**Subject:** MHI's Responses to US-APWR DCD RAI No.588-4617 REVISION 0

Response to Request for Additional Information  
No. 588-4617 Revision 0

**US-APWR Design Certification  
Mitsubishi Heavy Industries  
Docket No. 52-021**

**RAI NO.:** NO. 588-4617 REVISION 0  
**SRP SECTION:** 05.03.02 – Pressure-Temperature Limits, Upper-Shelf Energy, and Pressurized Thermal Shock  
**APPLICATION SECTION:** 05.03.02/ Technical Report MUAP-09016, Rev.1  
**DATE OF RAI ISSUE:** 5/11/2010

Figure 7-1 Generic P-T Limit Curves for Heatup, Inservice Leak and Hydrostatic Testing, and Criticality up to 60EFPY

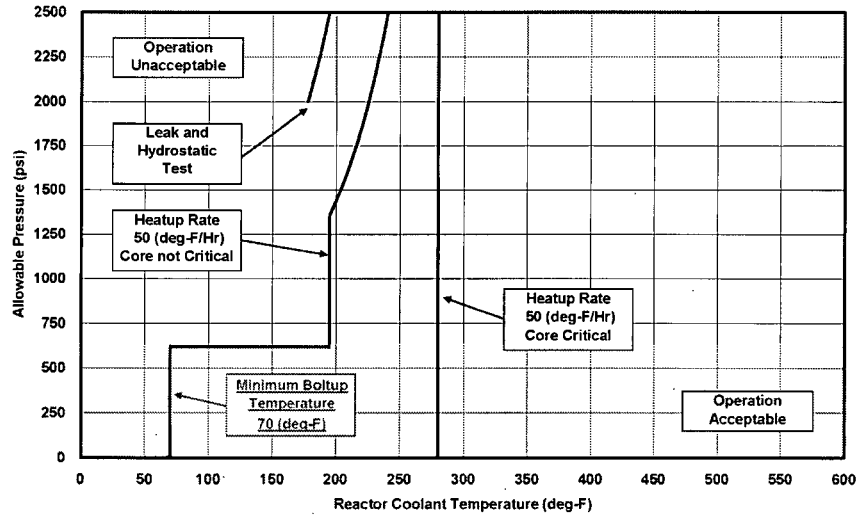
To address PTLR Criterion 6 (GL 96-03), clearly identify the minimum boltup temperature on the P-T limit curve (MUAP-09016, Rev.1, Figure 7-1).

Figure 7-1 of Technical Report MUAP-09016, Rev.1 will be revised to identify the minimum boltup temperature (70°F) described in Subsection 7.3.3.

Figure 7-2 Generic P-T Limit Curve for Cooldown up to 60EFPY

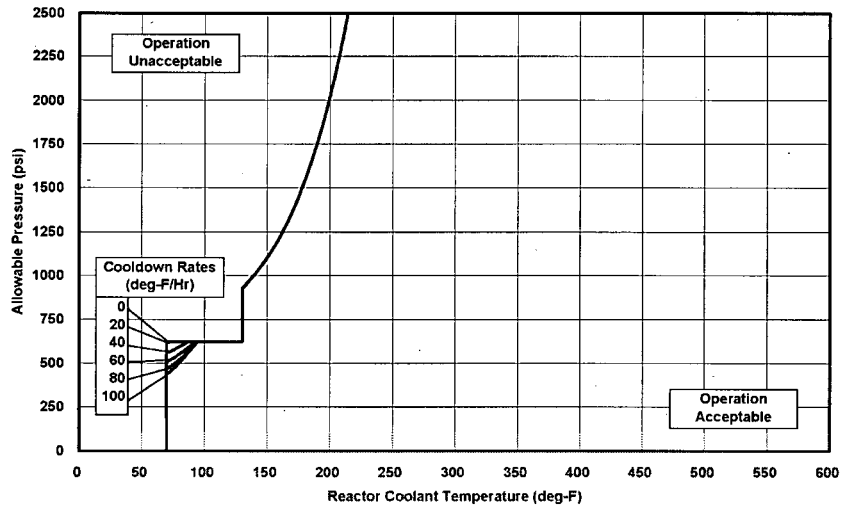
Provide a table of the data points (reactor coolant temperature vs. pressure) for each pressure-temperature (P-T) curve displayed in Technical Report MUAP-09016, Rev. 1.

- Data Points for Figure 7-2

Reactor Coolant Temp. (°F)	Allowable Pressure (psi)					
	Cooldown Rate					
	0 (°F/Hr)	20 (°F/Hr)	40 (°F/Hr)	60 (°F/Hr)	80 (°F/Hr)	100 (°F/Hr)
70	0 ~ 621	0 ~ 618	0 ~ 559	0 ~ 508	0 ~ 465	0 ~ 435
77	621	621	583	538	503	482
86	621	621	619	585	561	553
95	621	621	621	621	621	621
130	621 ~ 926	621 ~ 923	621 ~ 923	621 ~ 923	621 ~ 923	621 ~ 923
131	934	931	931	931	931	931
140	1007					
149	1092					
158	1195					
167	1320					
176	1466					
185	1643					
194	1855					
203	2109					
212	2413
